26 September 2022
Ref: 5105

Re: Application for S.4.55 (1A) Modification of Development Consent 2012/381 at Lot 3 DP 1247192 and Lot 12 DP 1226839, Seaside Drive, LAKE CATHIE

Figure 4: Revised Amended Subdivision Plan – removal of laneways and Bombora Way, Ocean Blue Boulevard

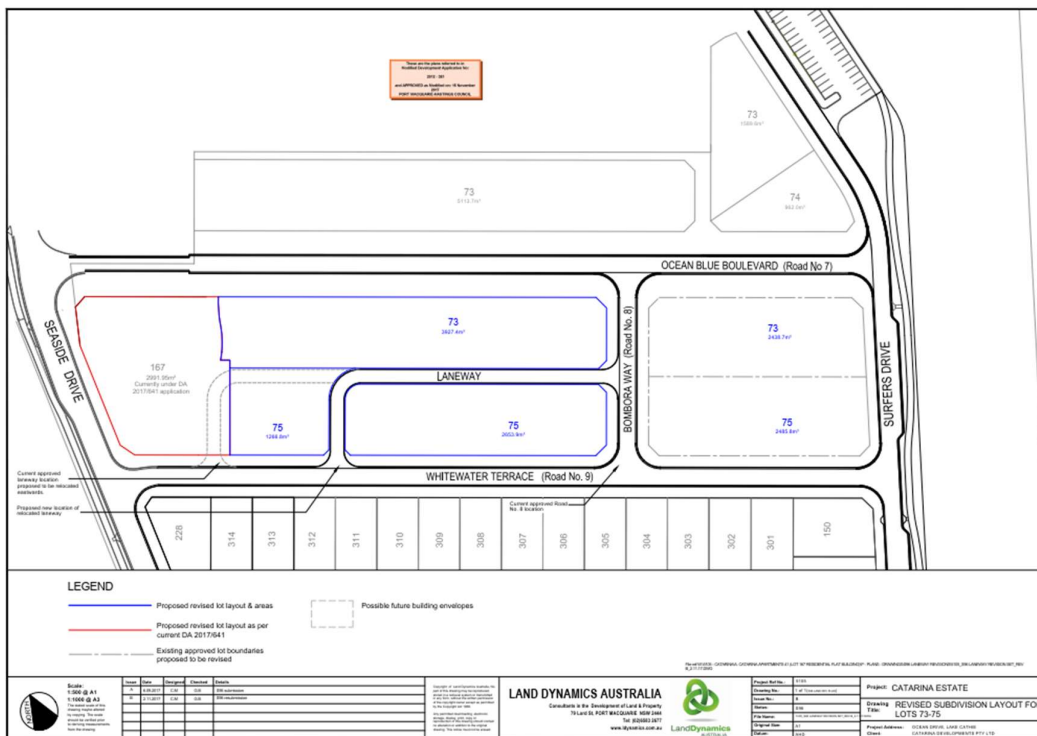
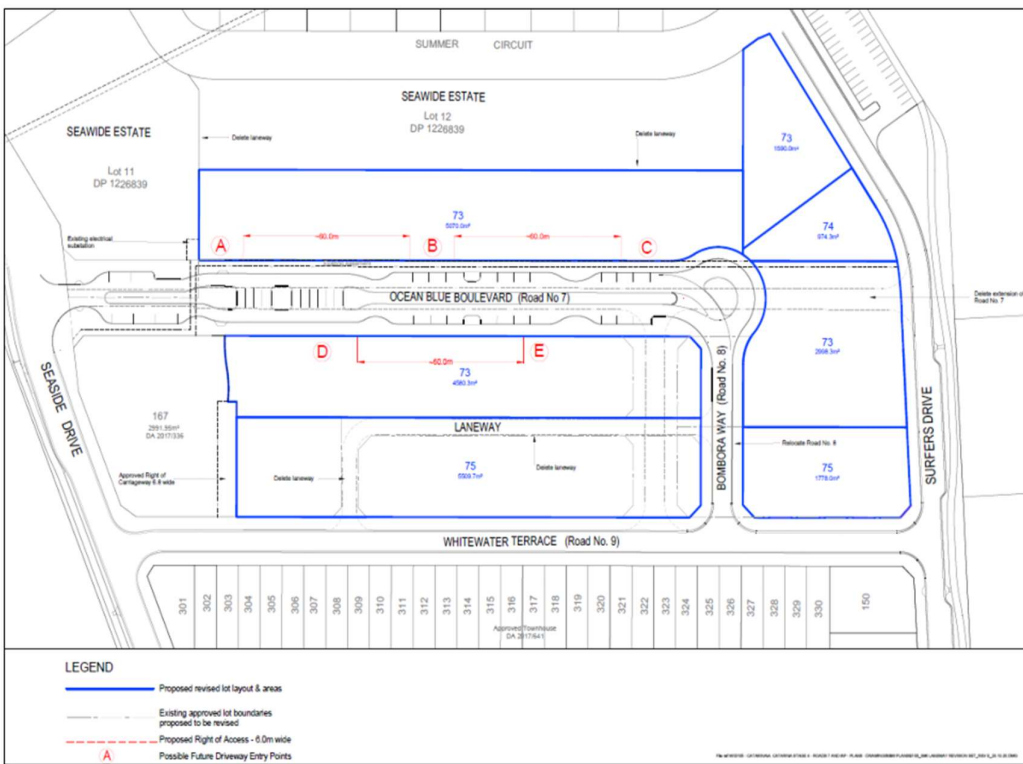
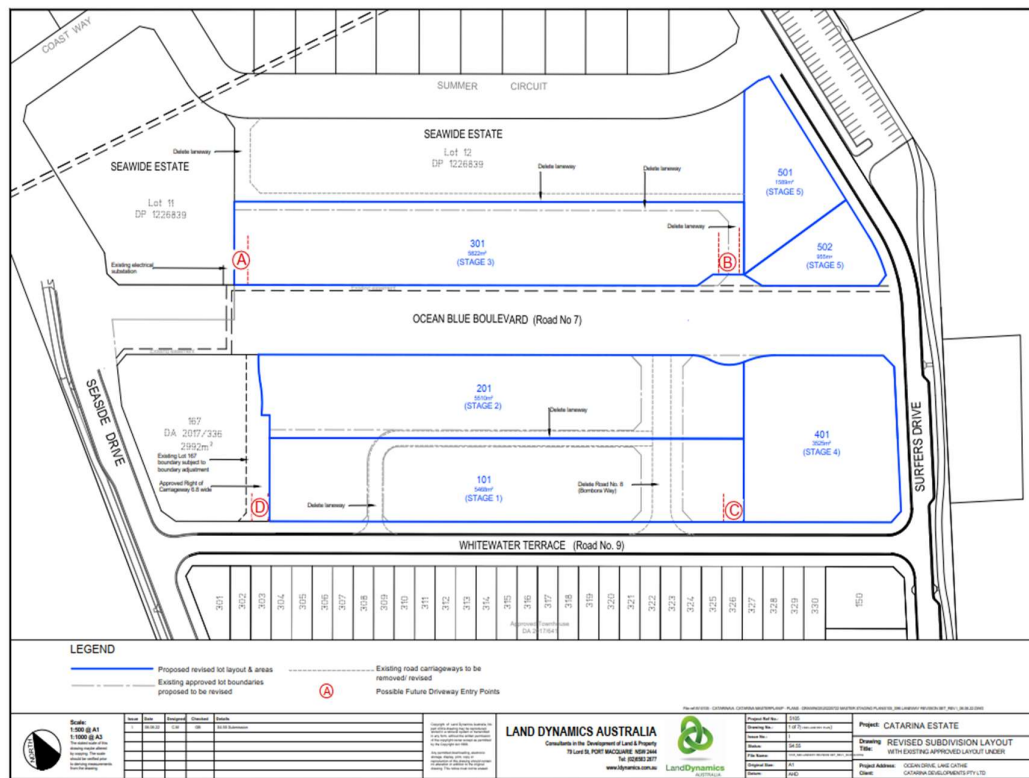
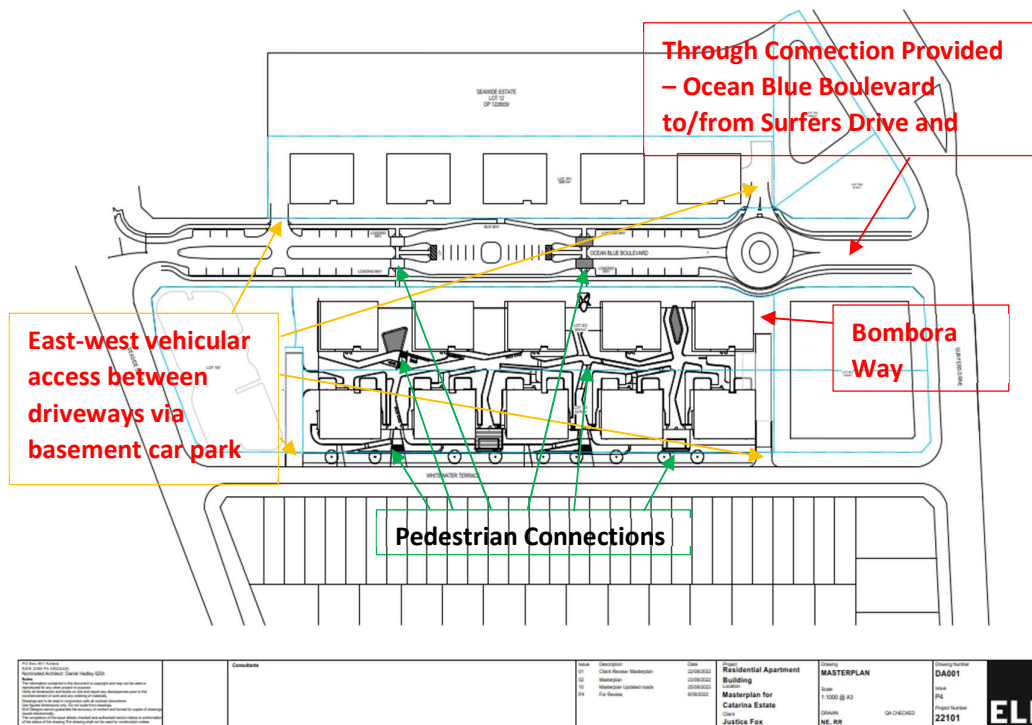
- Maintain the originally approved east-west Ocean Blue Boulevard/main street.
- Delete the previous Bombara Way connection between Ocean Blue Boulevard to Whitewater Terrace.
- Delete the east-west mid-block laneways to the north and south of Ocean Blue Boulevard.
- Provide new pedestrian north-south linkages between Ocean Blue Boulevard and Whitewater Terrace.
- Subdivide the land in a staged progression to ensure efficiencies in the development of the Catrina Hilltop Village Precinct.

This subdivision plan has been revised and is to be replaced with **Figure 4**. This plan shows the proposed revised subdivision layout, includes deletion of Bombara Way and laneways from the plans, connection along Ocean Blue Boulevard between Seaside Drive and Surfers Drive, and identifies the vehicular access points to the carpark basements.

“ Whilst it is considered that there may be some merit to investigating an alternate design for Ocean Blue Boulevard, linking to Surfers Dr via Bombora Way and Whitewater Terrace, it is considered that further engineering information is necessary to demonstrate that a suitable road gradient is not achievable directly to Surfers Dr in the concept approval location. This should also be compared to the existing Whitewater Terrace road gradient. It is also considered necessary to provide for appropriate details to secure public pedestrian connection directly through to Surfers Dr and the Rainbow Beach car park in a timely manner. The modification application information does not appear to detail at what stage the pedestrian connection will be provided. This is considered particularly important given the proposal to delete the more direct public road connection.”

Figure 5 provides an annotated illustration of the proposed amendments on the revised plan.

It is no longer proposed to close the eastern end of Ocean Blue Boulevard. Images of the amended road configuration, **Figure 4 - Figure 6** identify a through road/main street being Ocean Blue Boulevard connecting vehicular and pedestrian access east/west between Seaside Drive and Surfers Drive. It is noted from comments provided by PMHC at a Pre-lodgement meeting on 3 May 2022 relating to the future built form development application, that this amended road configuration is supported in principle. A copy of the Pre-lodgement Minutes is provided at **Annexure E**.

Figure 6: Integrated Basement Carpark Access

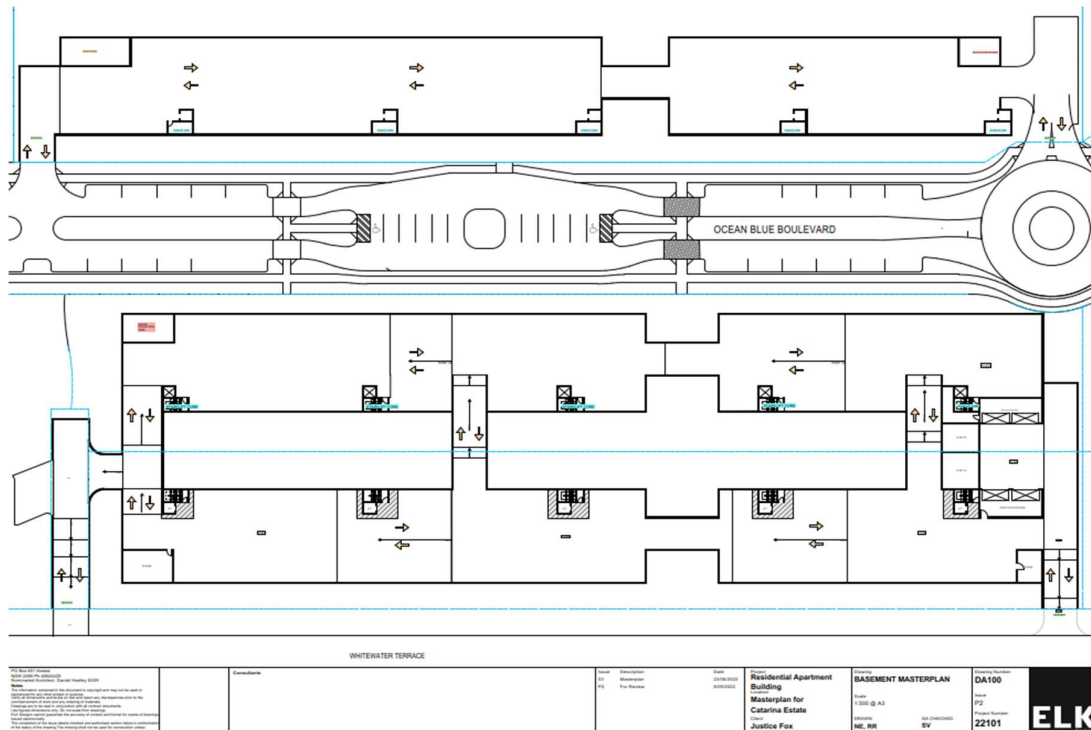
- a) The laneways were approved to allow for vehicles to service the mixed-use zoned land on Ocean Blue Boulevard and to provide a higher level of urban design and amenity outcomes in the hilltop village. By removing the laneways, servicing will inevitably occur along Ocean Blue Boulevard as indicated in the modification application. The application does not detail where on-street loading bays would be located, it is likely that they will reduce on-street parking and increase the potential for vehicle and pedestrian conflicts.

- b) The proposed restriction of vehicle crossovers in the five nominated locations will additionally reduce on-street parking availability and increase vehicle and pedestrian conflict points. These nominated access locations appear to be approximately 15m in width and could in effect result in more than one access point in each location. The nominated locations directly conflict with pedestrian crossing points and nominated on-street parking. Currently, there is nothing to prevent the B4 zoned land from being subdivided into smaller, individual lots in future. If this were to happen, then each individual property would be entitled to a driveway onto Ocean Blue Boulevard (up to 5.5m wide), further negatively impacting on parking, pedestrian conflict potential and urban design outcomes.

- c) Whilst it is noted that an integrated basement design is being worked on by the proponent so as to potentially provide for a similar function to a laneway, this does not provide sufficient certainty. Relying on such a significant development to provide for an integrated planning outcome at a later stage is considered to be a high-risk solution and not appropriate for a greenfield site. The current approved laneways allow for a range of development outcomes in the future. Whilst Council staff are open to considering an alternate road structure for the hilltop village, a suitable alternative proposal is likely to require a more integrated approach that provides for a greater level of certainty. This has been previously communicated to the proponent on numerous occasions.”

The northern basement (Stage 3), proposed Lot 301 will be accessed from two (2) vehicular access points off Ocean Blue Boulevard located at the eastern and western end of the proposed apartment buildings/basement. The southern basement (Stages 1 and 2), proposed Lot 101 and Lot 102 will be accessed from two (2) vehicular access points off Whitewater Terrace. This integrated basement arrangement is shown in **Figure 6**.

The integrated basement arrangement would allow for waste collection from the basement entry turnarounds. It is likely that an on-street loading bay would be the most practical means of servicing the ground floor commercial premises on Ocean Blue Boulevard, and on-street loading bays have been incorporated along Ocean Blue Boulevard, refer to **Figure 6**.
